TO: New Home
ATTN: Steven Kirby
PROJECT #: 21-2780-B (31-WB)
PAGE: 1 of 1
DATE: October 4, 2023
LOCATION: 44 Willow Creek Place
PLAN REF: Lot 31 Woodbridge by New Home
 Project# 21-2780

THE FOLLOWING CHANGE(S) OR PROPOSED CHANGE(S) LISTED BELOW ARE DEVIATIONS OR CLARIFICATIONS FOR THE ABOVE REFERENCED PLANS:

OPT. FIREPLACE AT PATIO
 SCALE: 1/8"=1'-0" ON 11x17, 1/4"=1'-0" ON 22x34

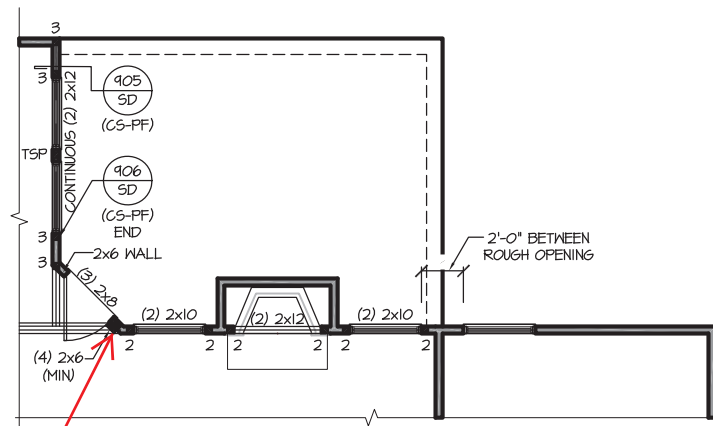
(3) 2X6 JACK STUDS AND
 SINGLE 2X6 KING STUD.
 ADDITIONAL 4 STUDS ADDED
 AT THE CORNER.
